Sales & Application Note N1- CB19

The release of the CB 19 occurred which replaces the CB 9 board.
 The features are similar to other Menu driven control boards.

1. RX1 & RX2v1

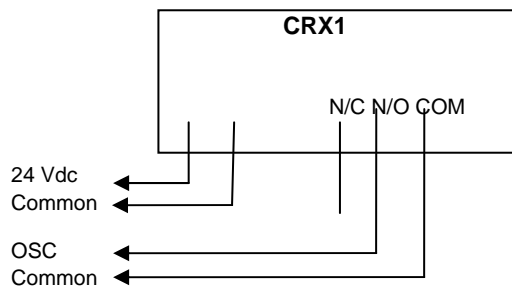
These receivers can be wired in to CB-19 boards using a harness # 01905.
 Please ensure a suitable antenna wire is used 27MHz 1500mm length.

○ Gate Solenoid Lock:

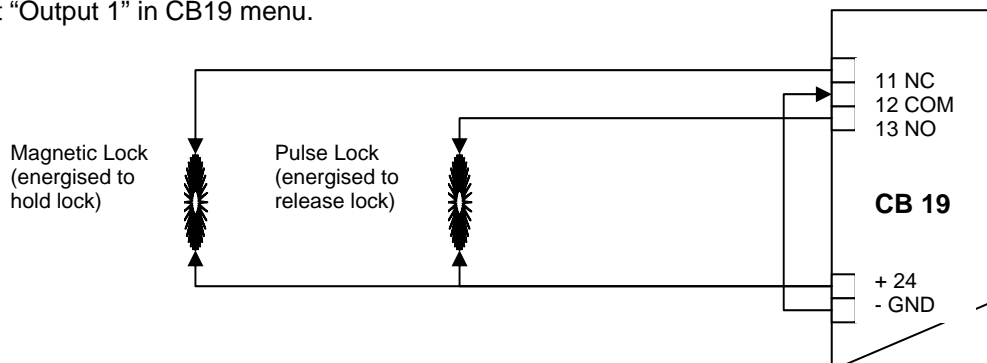
Set "Output 1" in CB19 menu.

○ **3 Wire Terminal Block:**

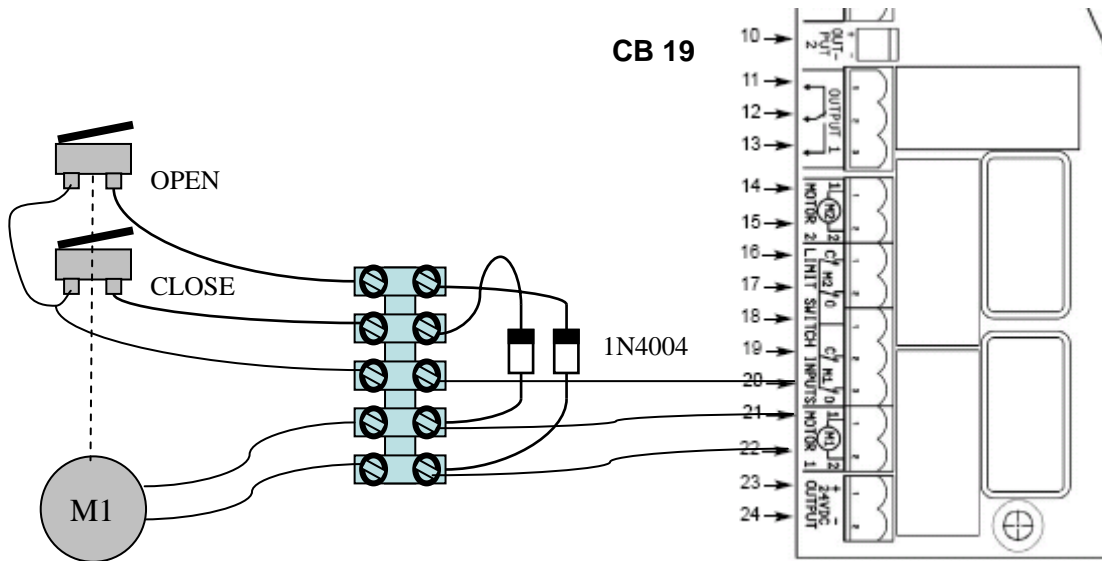
Wiring details when using a terminal block for a 3 wire system. Duplicate for M2 wiring, see page 6 of the CB19 manual.
